PIC24FJ256GB110 Family Silicon Errata and Data Sheet Clarification

The PIC24FJ256GB110 family devices that you have received conform functionally to the current Device Data Sheet (DS39897C), except for the anomalies described in this document.

Data Sheet Clarifications

The following typographic corrections and clarifications are to be noted for the latest version of the device data sheet (DS39897C):

FIGURE 2-3 FREQUENCY vs. ESR PERFORMANCE FOR SUGGESTED VCAP

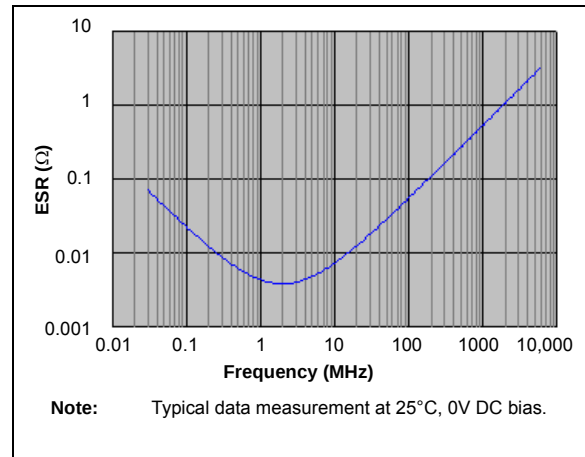
Section 2.4 Voltage Regulator Pins (ENVREG/DISVREG and VCAP/VDDCORE) has been replaced with a new and more detailed section. The entire text follows:

When the regulator is enabled, a low-ESR ($< 5\Omega$) capacitor is required on the VCAP/VDDCORE pin to stabilize the voltage regulator output voltage. The VCAP/VDDCORE pin must not be connected to VDD and must use a capacitor of 10 μF connected to ground. The type can be ceramic or tantalum. Suitable examples of capacitors are shown in **Table 2-1**. Capacitors with equivalent specifications can be used.

Designers may use **Figure 2-3** to evaluate ESR equivalence of candidate devices.

FIGURE 2-4 DC BIAS VOLTAGE vs. CAPACITANCE CHARACTERISTICS

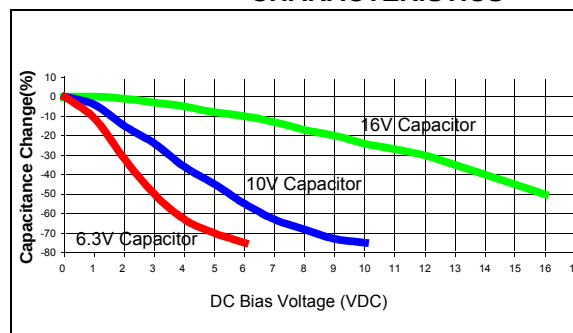
A typical DC bias voltage vs. capacitance graph for 16V, 10V and 6.3V rated capacitors is shown in Figure 2-4.

When selecting a ceramic capacitor to be used with the internal voltage regulator, it is suggested to select a high-voltage rating, so that the operating voltage is a small percentage of the maximum rated capacitor voltage. For example, choose a ceramic capacitor rated at 16V for the 2.5V core voltage. Suggested capacitors are shown in Table 2-1.

FIGURE 29-1: PIC24FJ256GB110 FAMILY VOLTAGE-FREQUENCY GRAPH (INDUSTRIAL)

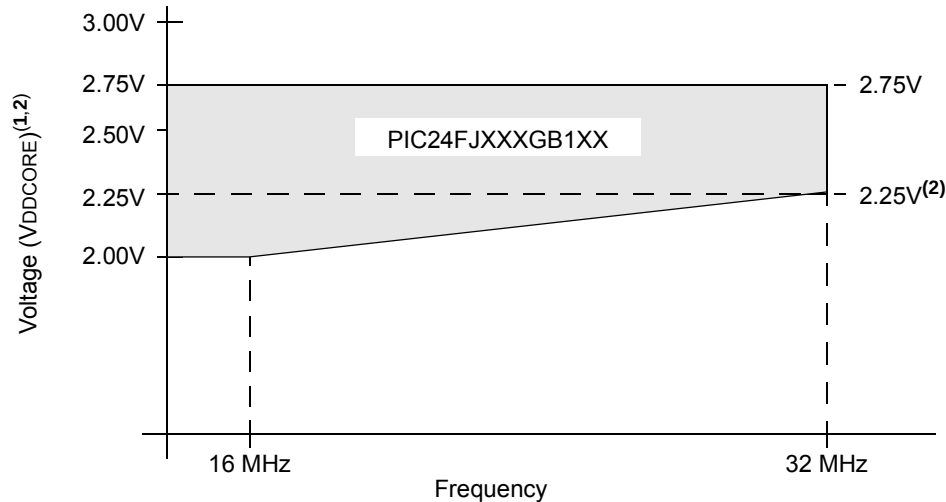
Figure 29-1 (“PIC24FJ256GB110 Family Voltage-Frequency Graph”) is amended by adding an additional footnote. The updated figure is shown below (changes in **bold**; bold in original removed for clarity).

For frequencies between 16 MHz and 32 MHz, $F_{MAX} = (64 \text{ MHz/V}) * (V_{DDCORE} - 2V) + 16 \text{ MHz}$.

Note 1: When the voltage regulator is disabled, V_{DD} and V_{DDCORE} must be maintained so that $V_{DDCORE} \leq V_{DD} \leq 3.6V$.

2: When the USB module is enabled, V_{USB} should be provided at 3.0V to 3.6V while V_{DDCORE} must be 2.35V. When the USB module is not enabled, the wider limits shaded in grey apply. The voltage on the V_{USB} pin should be maintained at (V_{DDCORE} – .3V) or greater. Optionally, the pin may be left in a high-impedance state when the USB module is not in use, but doing so may result in higher I_{PD} currents than specified.
